In the Matter of
LONG ISLAND LIGHTING COMPANY
(Shoreham Nuclear Power Station,
Unit 1)

Docket No. 50-322-OL
LBP-85-18
June 14, 1985

PARTIAL INITIAL DECISION
ON EMERGENCY DIESEL GENERATORS

Figure 2.

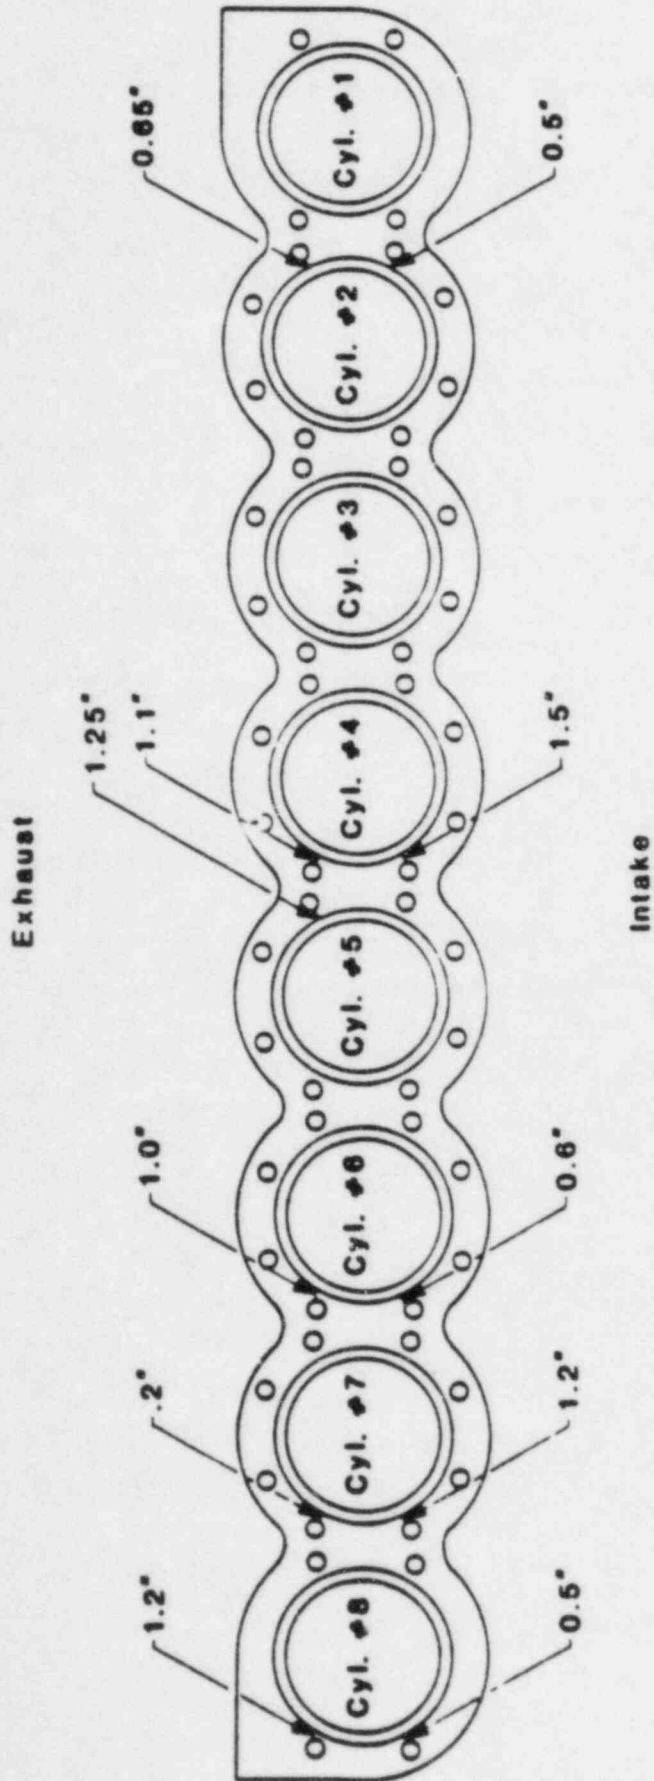
B-5. The location and depth of the ligament cracks were measured using a series of liquid penetrant, eddy current and visual inspections of the block tops, stud holes and cylinder liner landings. Id. at 13. EDG 101 had 13 ligament cracks, EDG 102 had 18 ligament cracks and EDG 103 had 21 ligament cracks at the time of these inspections. LILCO Exs.

B-16, B-17 and B-18. These cracks varied in depth, with the ones in EDG 103 being the most severe. Id. No ligament crack in EDGs 101 and 102 extended below a depth of 1.5 inches nor on to the liner landing. As of March 11, 1984, the original EDG 103 block had no measured ligament cracks deeper than 1.5 inches. The deepest stud-to-stud crack in the original EDG 103, between cylinders No. 4 and 5, was measured by eddy current to have a depth of 1.4 to 1.6 inches. LILCO Exs. B-16, B-17, B-18; McCarthy et al., ff. Tr. 24,372, at 14, 15; Tr. 28,823-24 (Johnson); Tr. 28,825-27 (Rau). The original EDG 103 also had seven surface "indications" (cracks which were not deep enough to be measurable), five of which occurred in stud-to-stud locations and two of which were located between a stud hole and the outer perimeter of the block top. Id.

Figure 3.

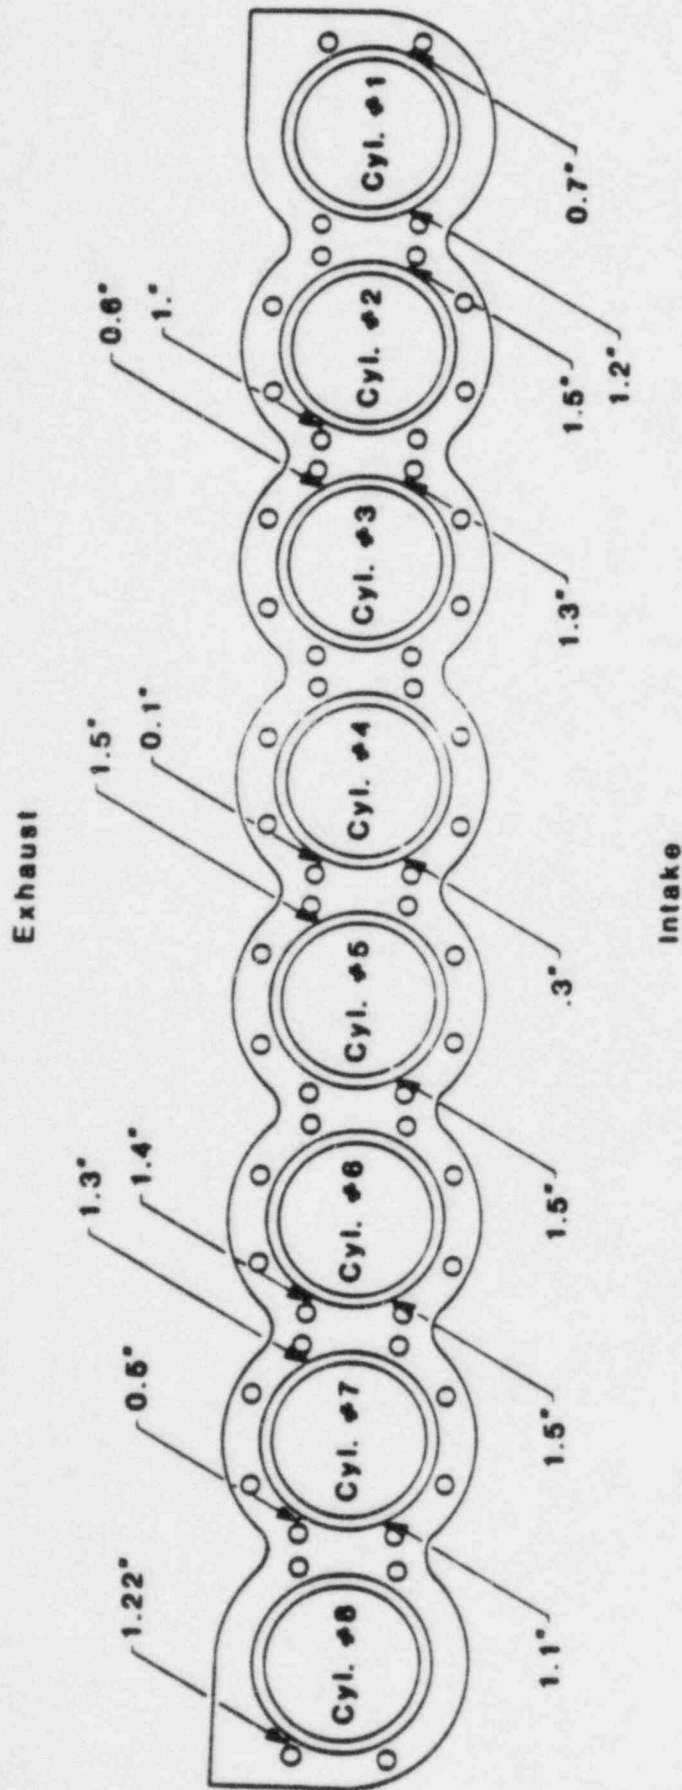
B-6. Following inspection, EDG 102 was operated through 100 starts to loads greater than 50 percent (i.e., greater than 1750 kw). McCarthy et al., ff. Tr. 24,372, at 15; LILCO Ex. B-21. Based on subsequent eddy current examination, LILCO concluded that there had been no discernible extension of cracks on the 102 block. Id. It appears, however, that this general conclusion was based on eddy current measurements only at cylinder No. 7. See Tr. 24,411 (Johnson); LILCO Ex. B-21. While this may be reassuring, since based on the EDG 102 crack map cylinder No. 7 has the worst cracks, we do not find it conclusive that no crack extension at all took place.

Figure 4.

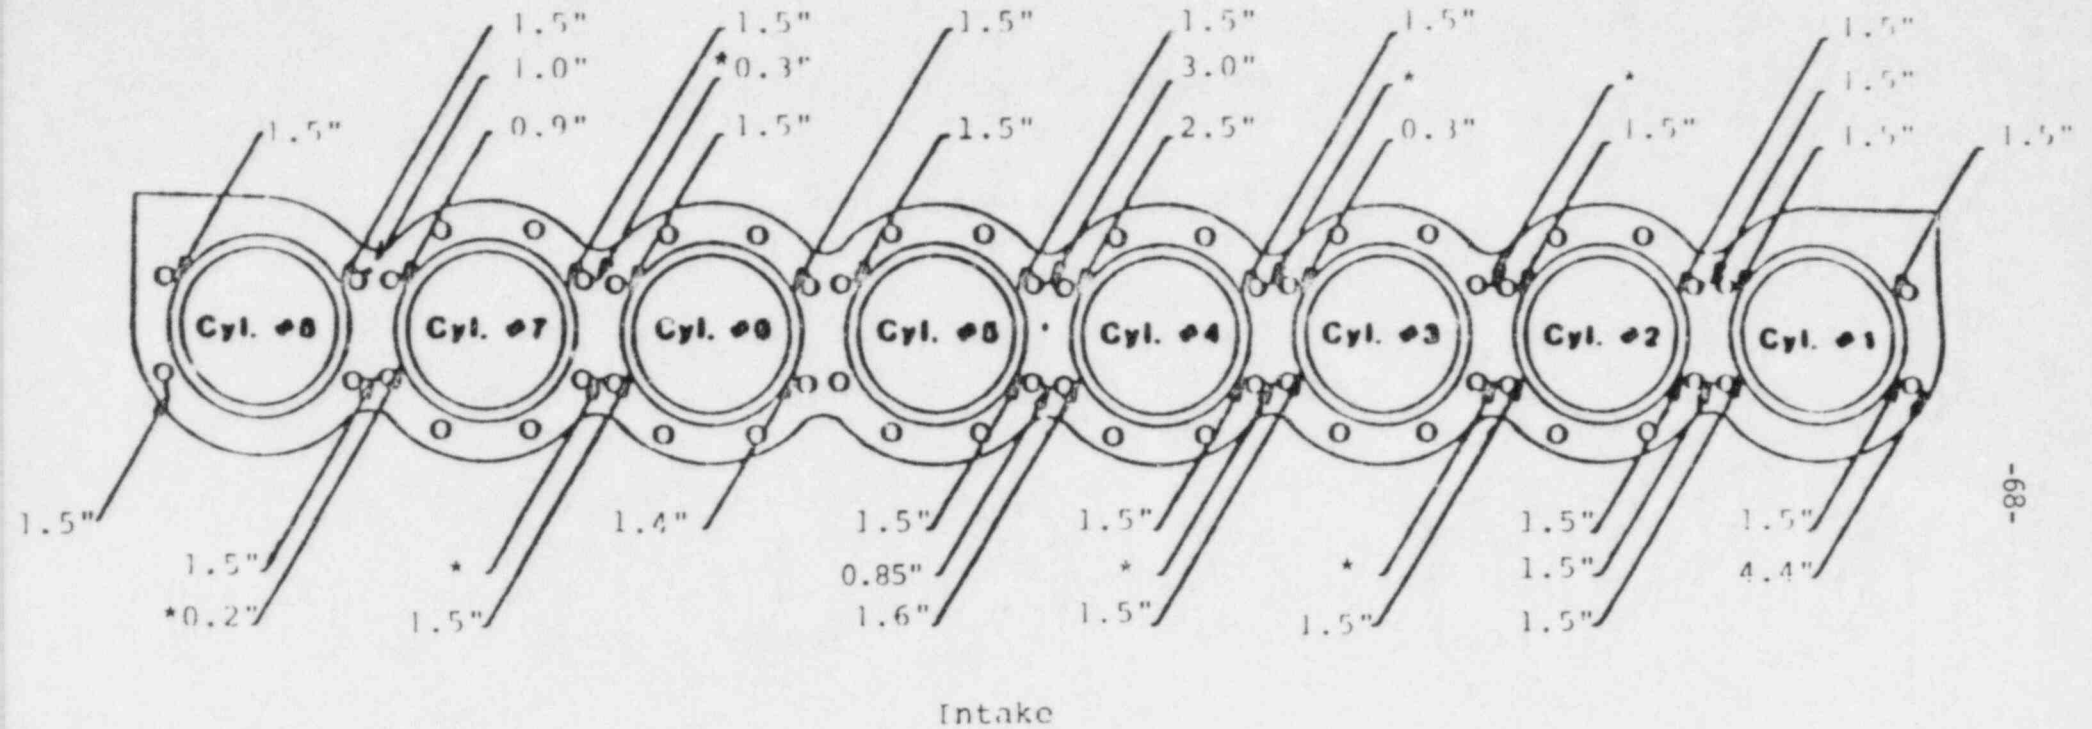
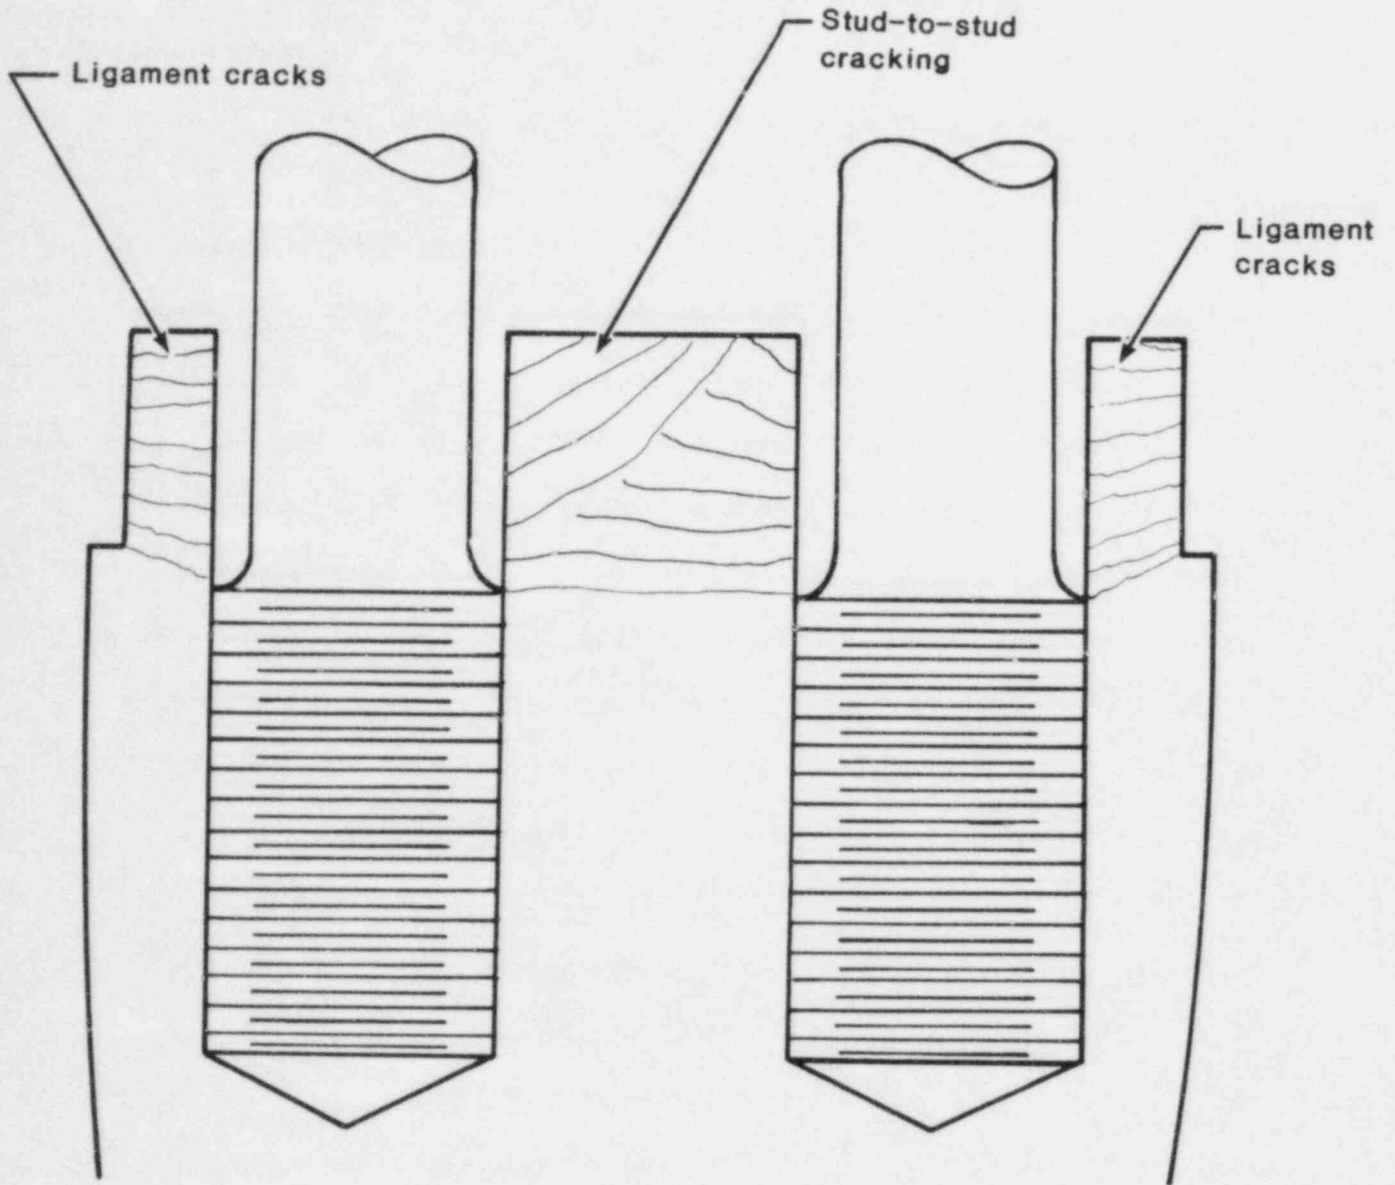
B-7. Between March 11 and April 14, 1984, EDG 103 underwent additional operational testing for a longer time at higher loads than the EDG 102 testing. LILCO Ex. B-15. On April 14, the EDG block experienced an abnormal load excursion in which the power demand exceeded the EDG capacity for approximately 25 seconds, causing the engine to slow from the normal 450 rpm to 390 rpm. The engine was operating with the fuel rack set at 3500 kw when the power demand from the site load was accidentally picked up. The engine speed slowed until the output breaker tripped due to low engine rpm; the diesel continued to run at no load for an additional ten minutes before it was shut down. McCarthy et al., ff. Tr. 24,372, at 17-18; Tr. 24,655-61 (Youngling, Seaman). The engine was later restarted and the qualification testing continued at 3900 kw for about 1.75 hours, when an operator noticed oil seeping from a crack running down the front of the block at cylinder No. 1, and the engine was shut down. The engine was operating satisfactorily and producing power prior to shutdown. McCarthy et al., at 17-18; Tr. 24,434 (McCarthy); Tr. 24,661-62 (Youngling). The area of this crack had not been inspected after the load excursion and before restarting the engine. Tr. 24,663 (Youngling). The crack was later measured to be 4.4 inches long at the front surface of the block. No one recalled its depth at the stud hole, but it would not be more than 4.4 inches because that was the largest measurement observed. Tr. 24,668 (Wells), Tr. 24,669 (Schuster, Johnson).

B-8. After shutdown of the EDG 103 engine on April 14, 1984, inspection of the block revealed that the deepest stud-to-stud crack, located between cylinders No. 4 and 5, had extended from a depth of 1.4 to 1.6 inches to a maximum depth of three inches.^{3/} McCarthy et al., ff. Tr. 24,372, at 18; Tr. 28,823-24 (Johnson); Tr. 28,905-06 (Rau); LILCO Exs. B-18, B-25. Between March 11 and April 14, 1984, additional ligament and stud-to-stud cracks had initiated and propagated at other block top locations; however, none of the ligament cracks extended on to the liner landing. McCarthy et al., ff. Tr. 24,372, at 18-19; Tr. 25,538 (Johnson); LILCO Exs. B-16, B-18, B-25.

B-9. Based on the lack of confidence that the EDG 103 block could be repaired satisfactorily, LILCO decided to replace it. Tr. 24,665-66 (Youngling). A new block was installed in the EDG 103 in June 1984. Johnson et al., ff. Tr. 28,799, at 5.
